RE: 160628 BYLONG COAL PROJECT FORESTRY NSW SUPPLEMENTARY RTS

PROPOSED BYLONG COAL PROJECT – FURTHER EPA COMMENT

Bylong Coal Project Response to Submissions on Groundwater

Project number G1606G
Document title Bylong Coal Project – Response to Supplementary Submissions on Groundwater
Site address Bylong, NSW
File name G1606.Response_to_Submissions_Final.docx

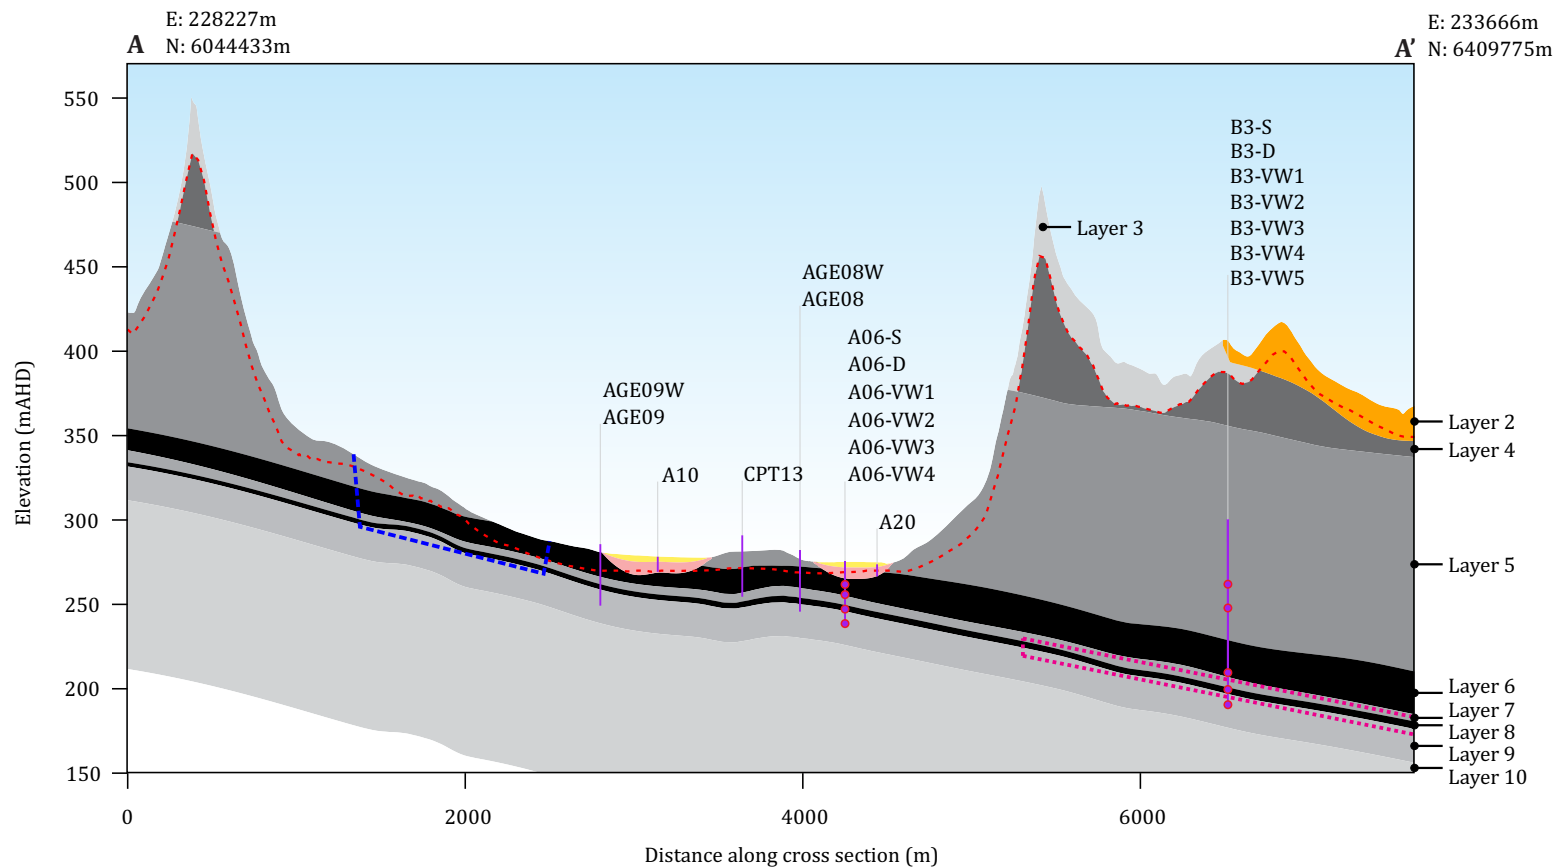
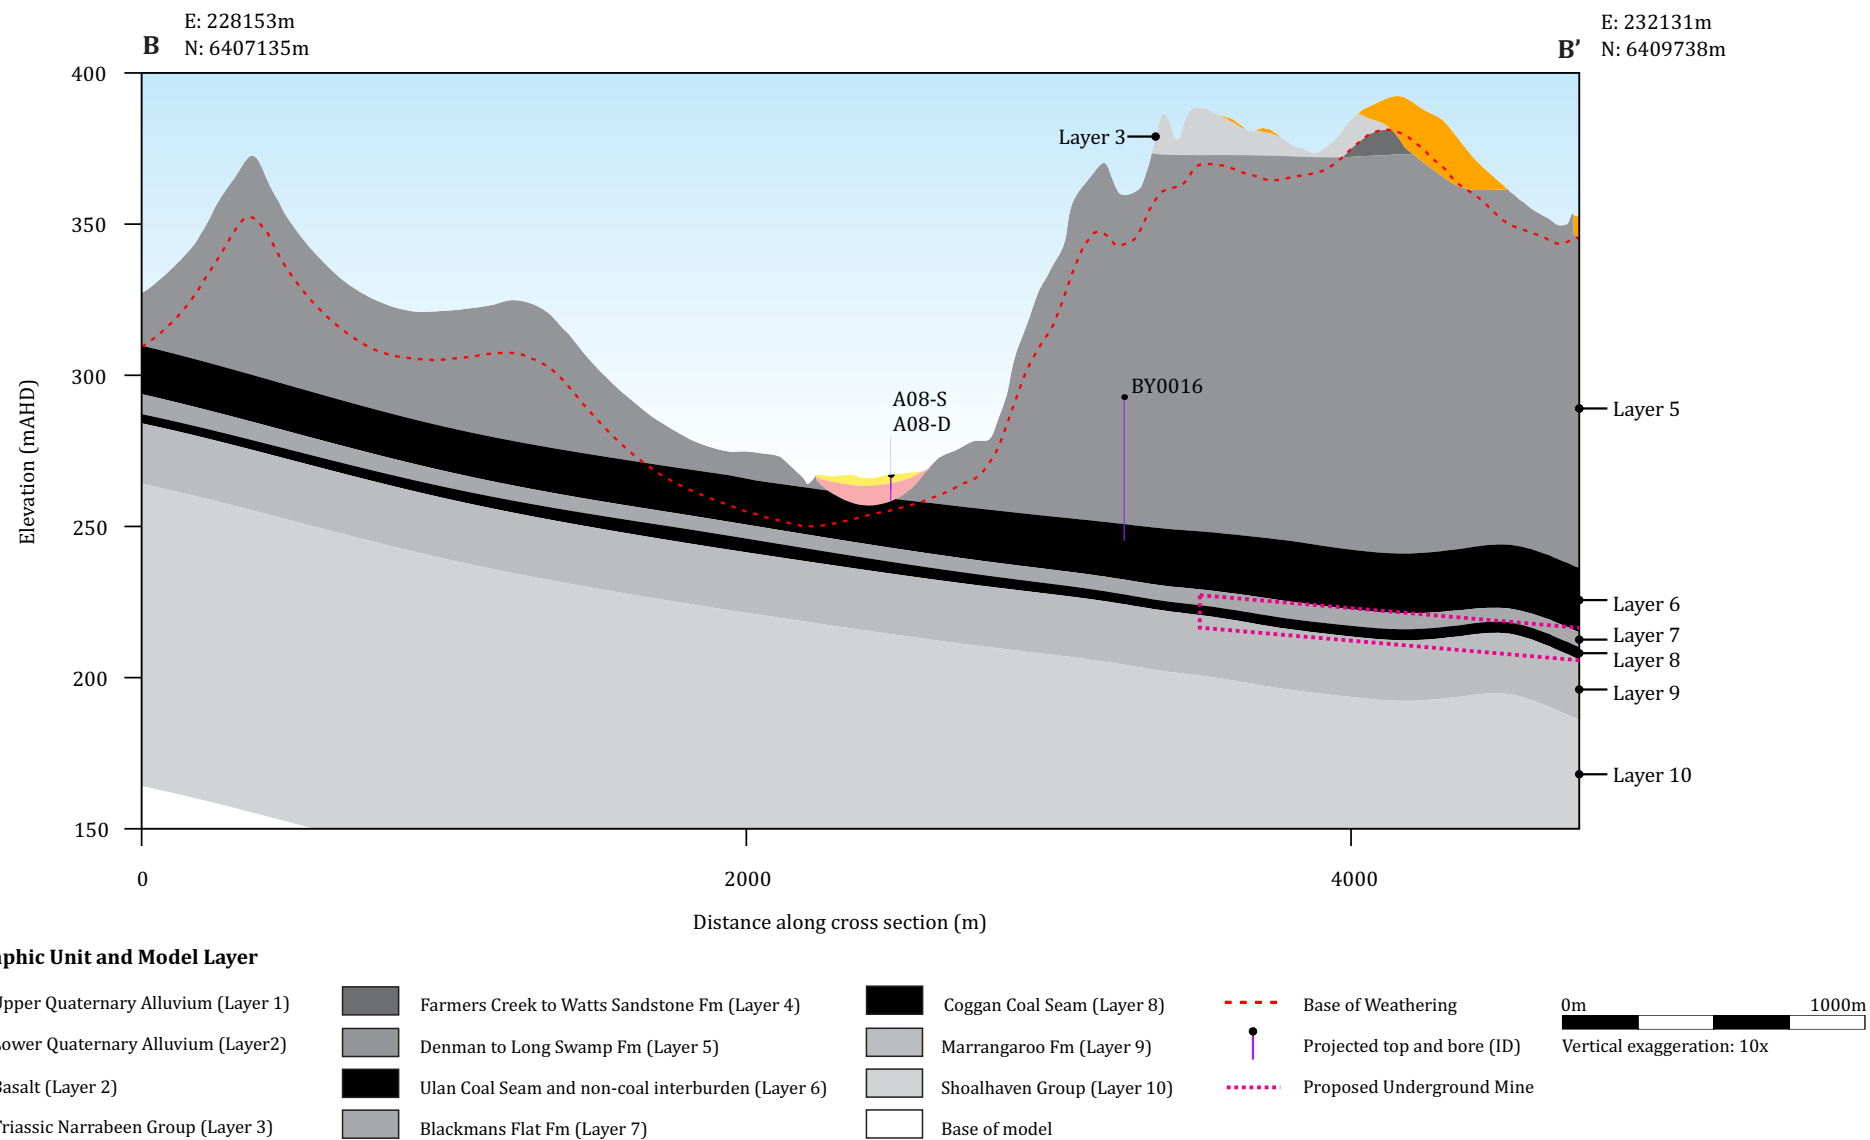
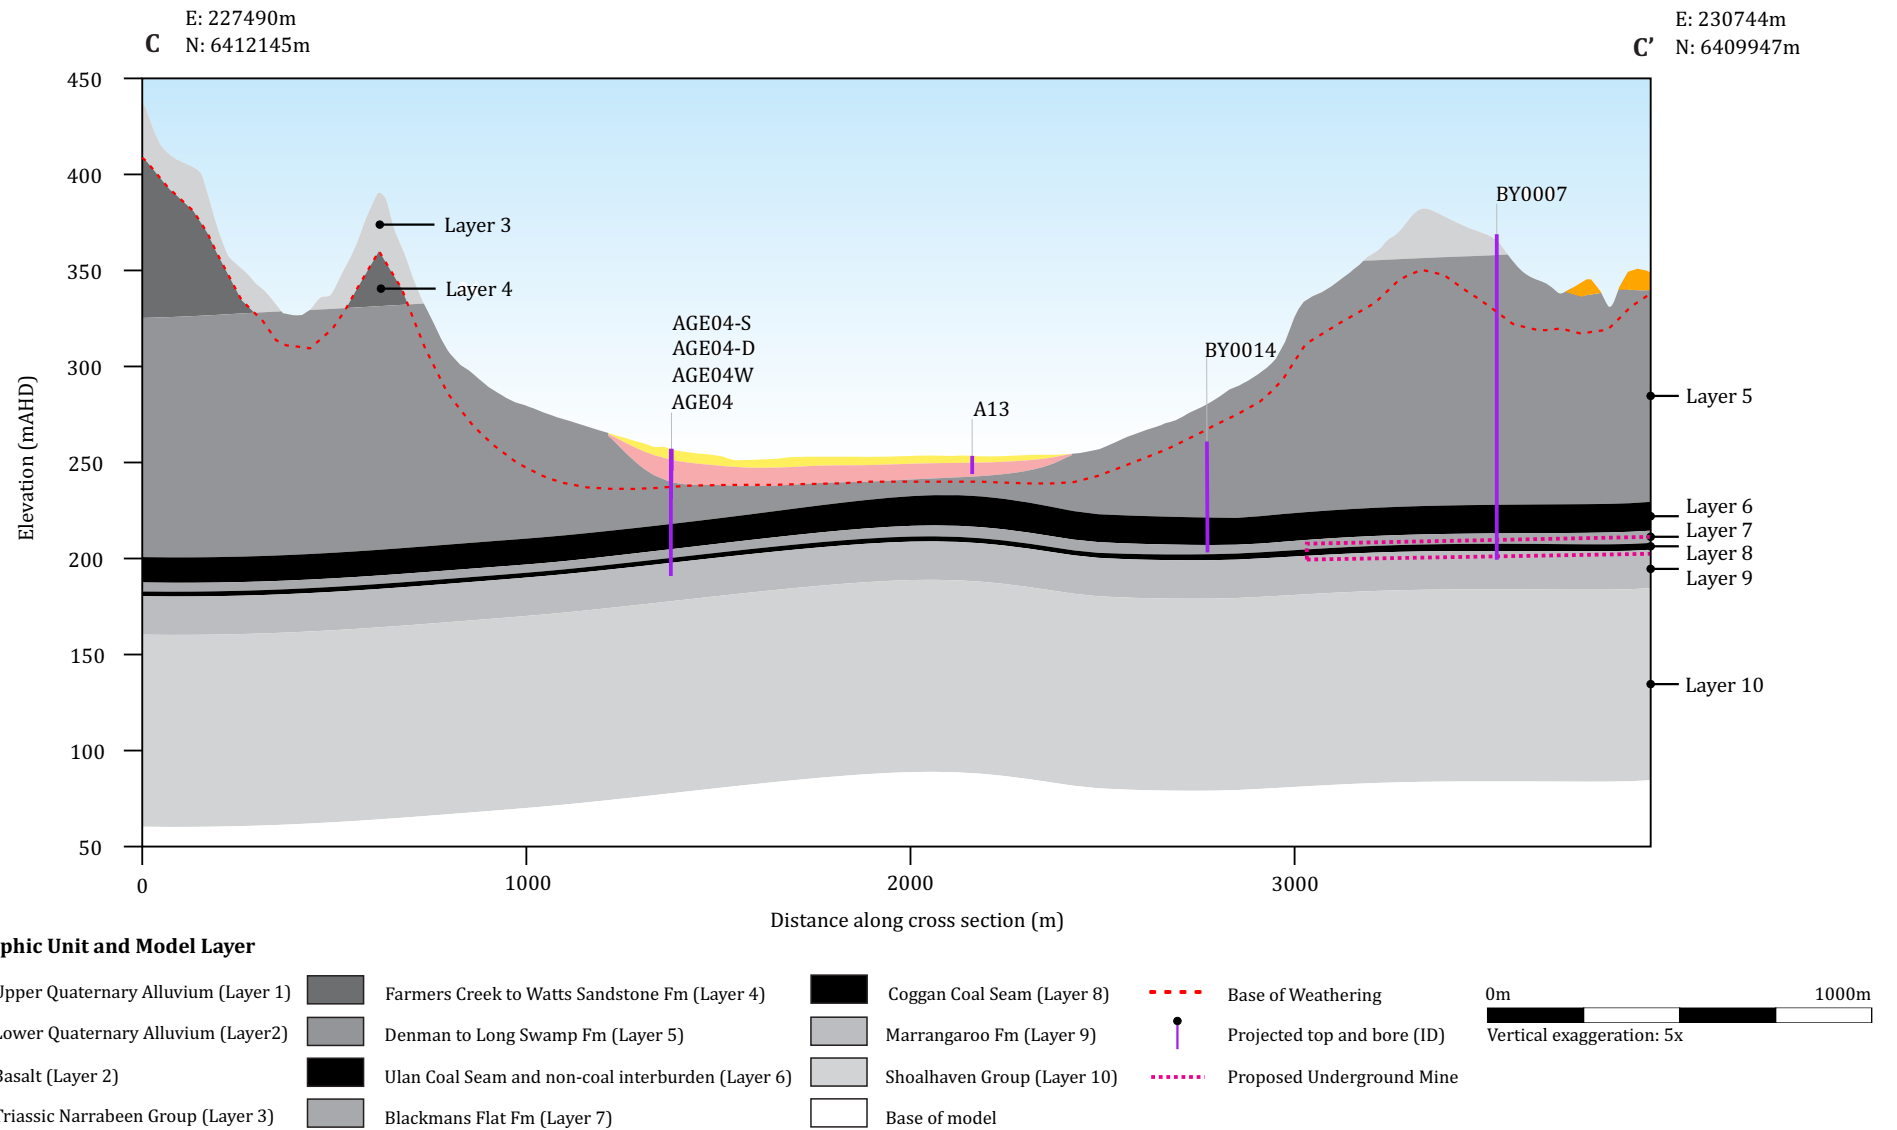
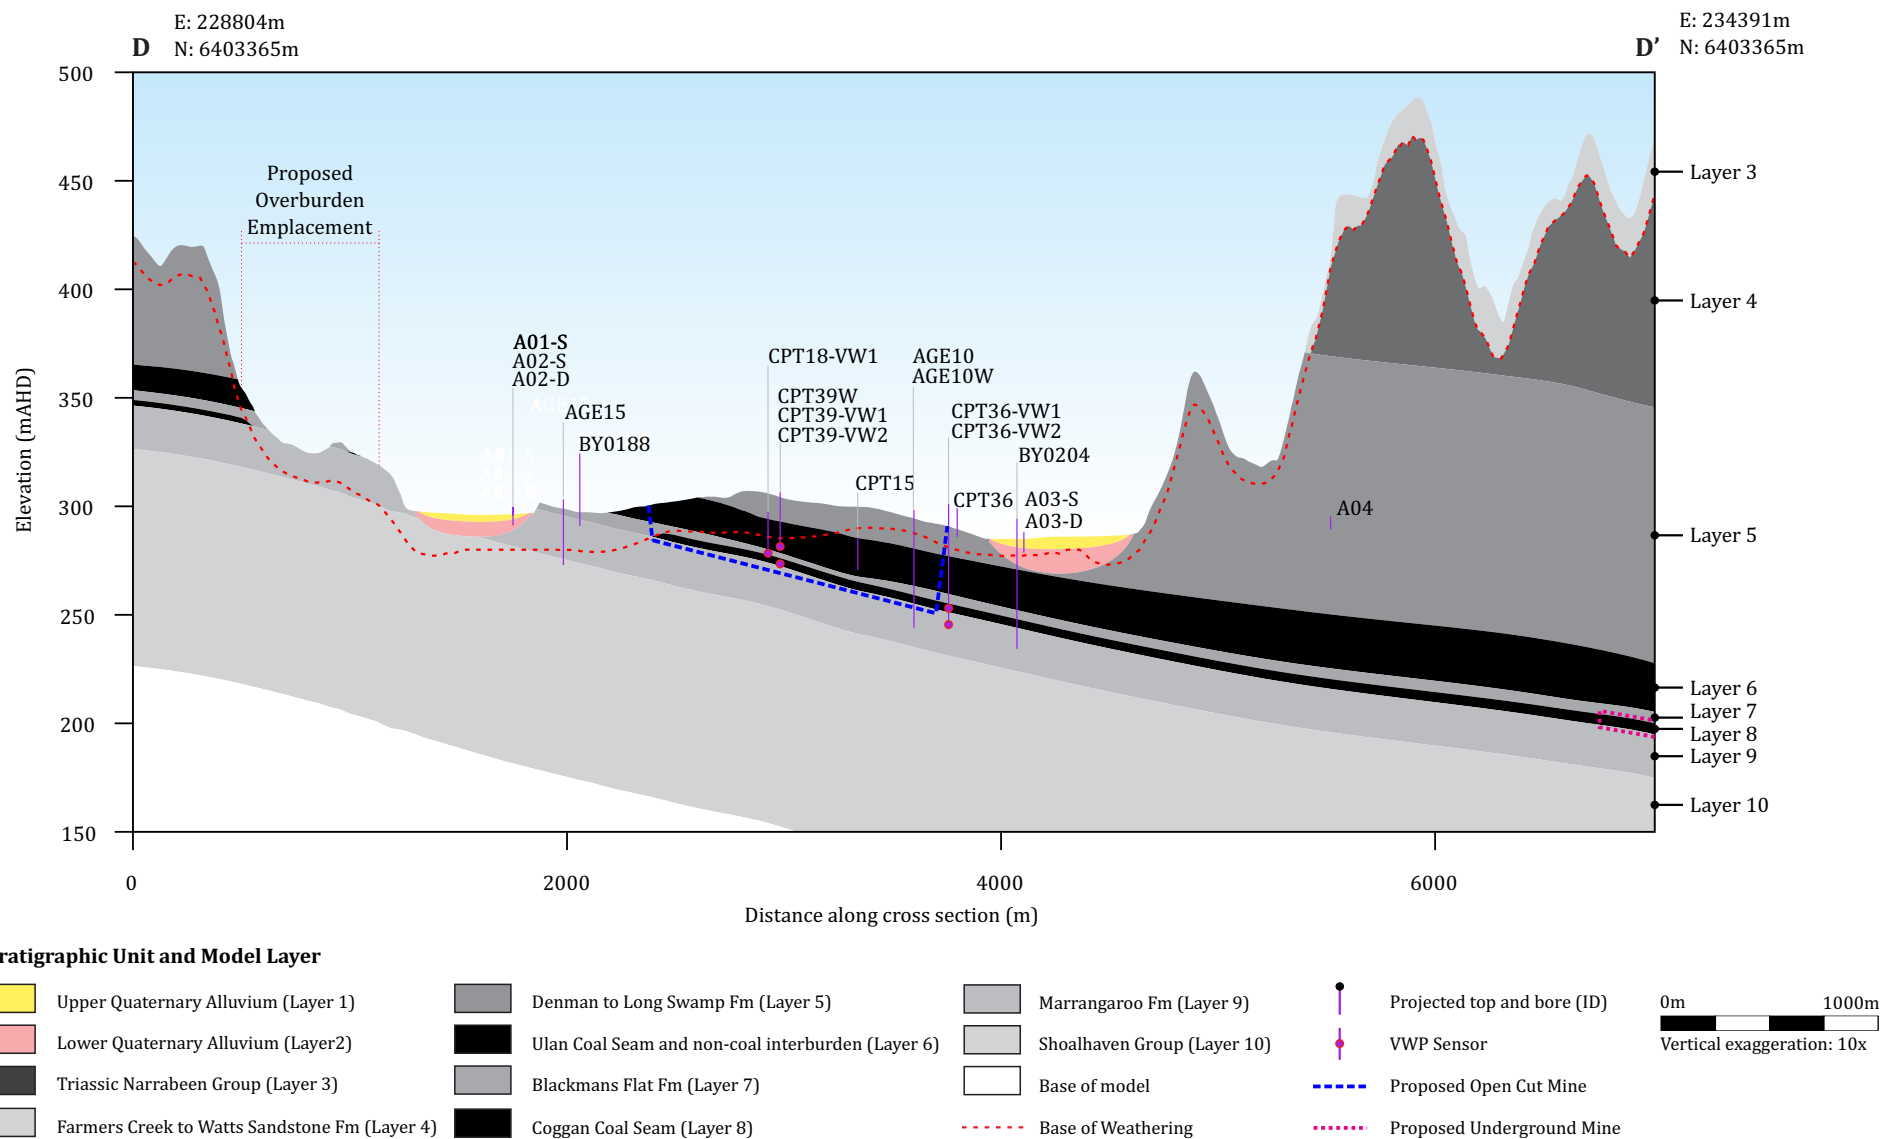
In DPI Water's submission on the RTS it requested additional cross-sections to understand the 3D conceptual geology along the groundwater flow paths from recharge areas towards open-cut or underground mines or beneath coal spoil emplacement areas and towards other water users with detail on the dipping Permian beds.

To address this request the cross sections through the alluvium provided in the RTS were increased both laterally and vertically to incorporate the Permian strata, the catchment area contributing streams and the proposed mining and emplacement areas. A new cross section was also provided through the proposed open cut and underground mining areas further south and upstream.

Figure 3-1 shows the locations of the cross sections, whilst Figure 3-2 to Figure 3-5 shows the geological units along each cross section line. The cross sections are based on the groundwater model and therefore show the stratigraphic unit(s) each model layer represents. Adjacent monitoring bores are projected onto each cross section.

FIGURE No:
5-19

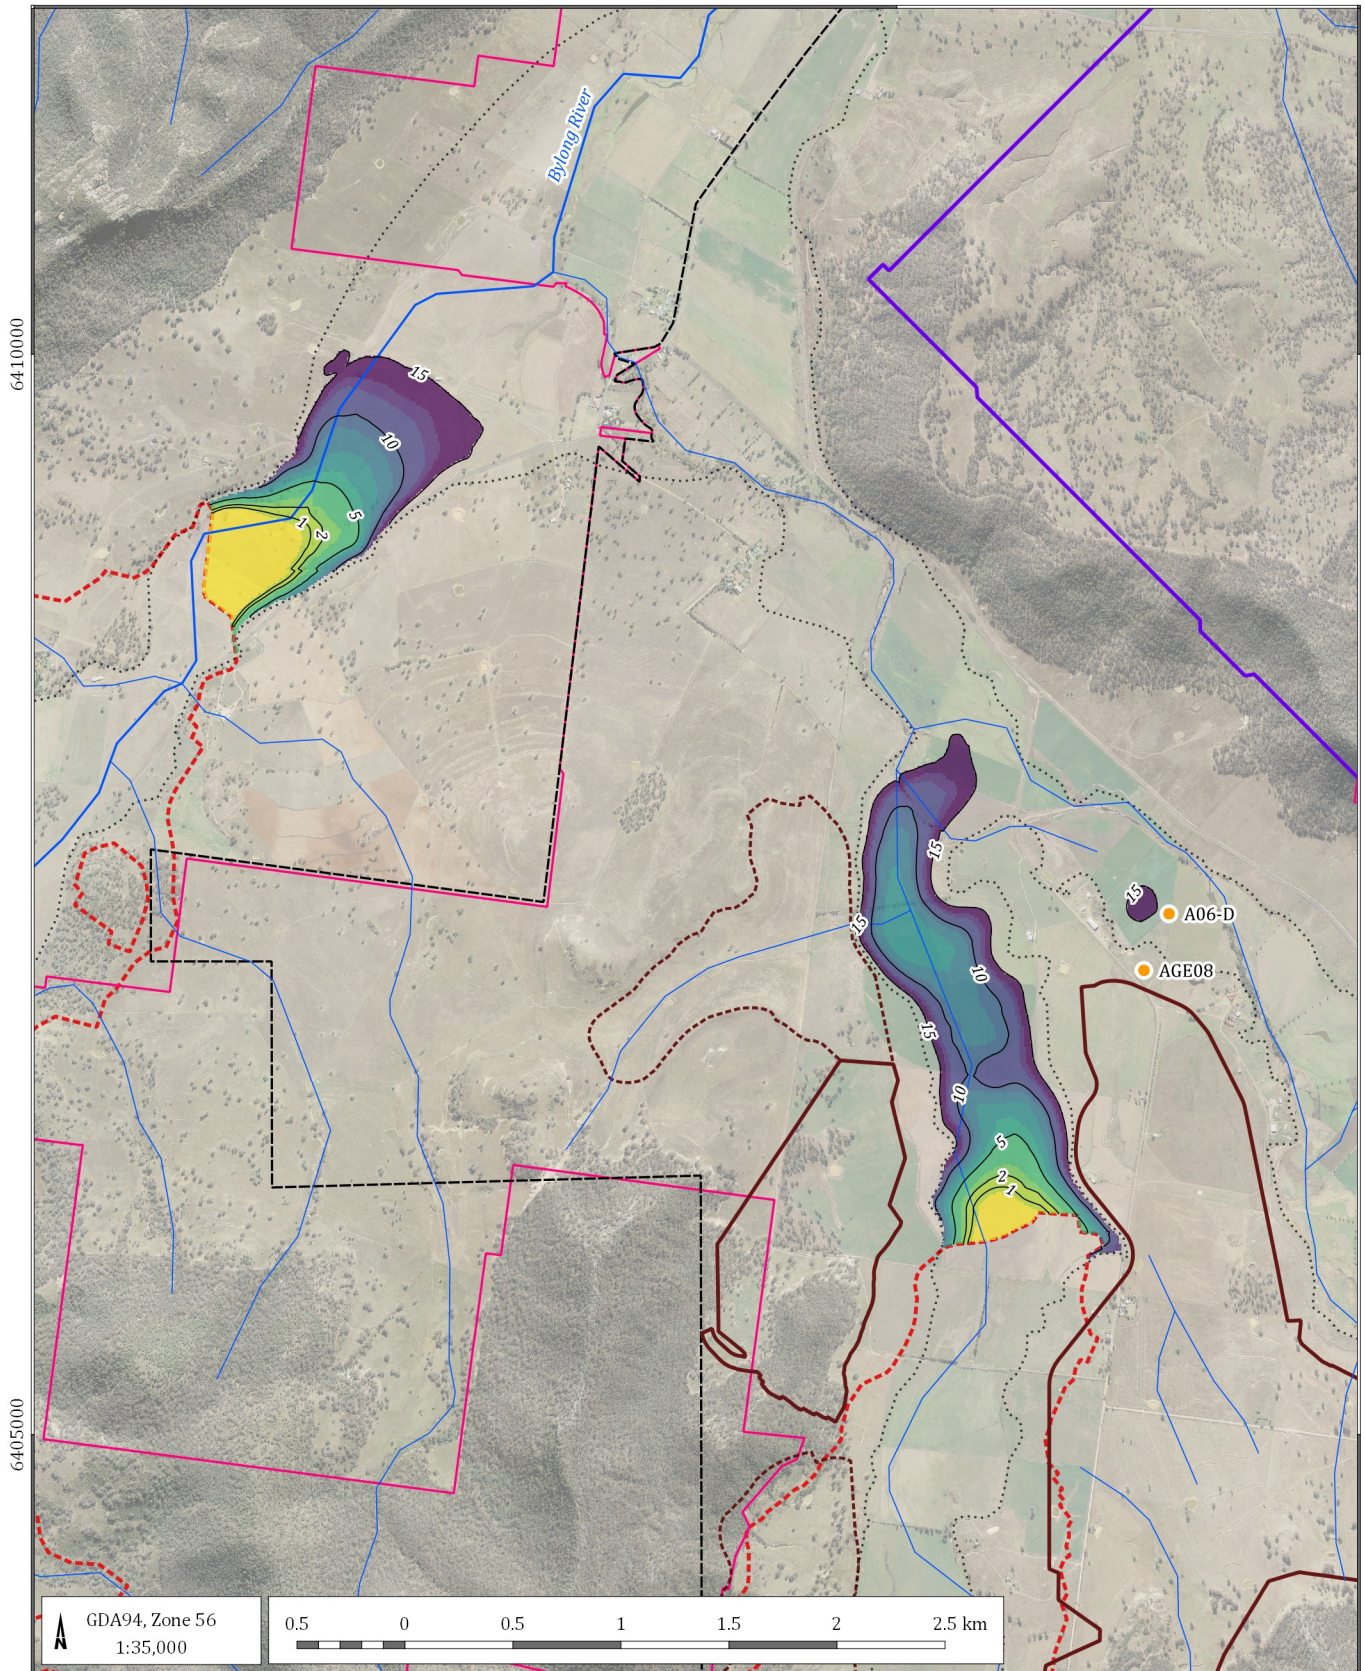
DPI Water interpreted from maps presented within the RTS document that a hydraulic connection between the Quaternary alluvial aquifer and the Coggan Coal seam aquifer was likely to exist. It is agreed that the available data does indicate in some areas there is a direct or direct hydraulic connection between the alluvium and the coal seams proposed to be mined. Figure 5-19 shows where the Coggan Coal seam either subcrops below the alluvium, or outcrops close to the land surface. The areas where the coal seam subcrops directly beneath the alluvium, or is separated by a thin layer of weathered Permian sediments will be areas where the connectivity is enhanced. Figure 5-19 shows this occurs primarily in the area of the Lee Creek alluvium between the Eastern and Western open cut mining areas. Towards the south of this area the coal seams outcrop above the water table and therefore do not have any direct connection with the alluvial aquifer.

The Supplementary RTS groundwater report (Appendix J of the Supplementary RTS) discussed this connectivity and provides a map (see Figure 5-19) showing where the coal encroaches closer to the base of the alluvium. Since the numerical models represented the connectivity created by the geological units (particularly in the case of the MODFLOW USG model which allows the pinching out of layers) the alluvial aquifer water is allowed to leak into the areas of sub-cropping Permian aquifers which are connected to the exposed faces within the open cut and underground mine areas.
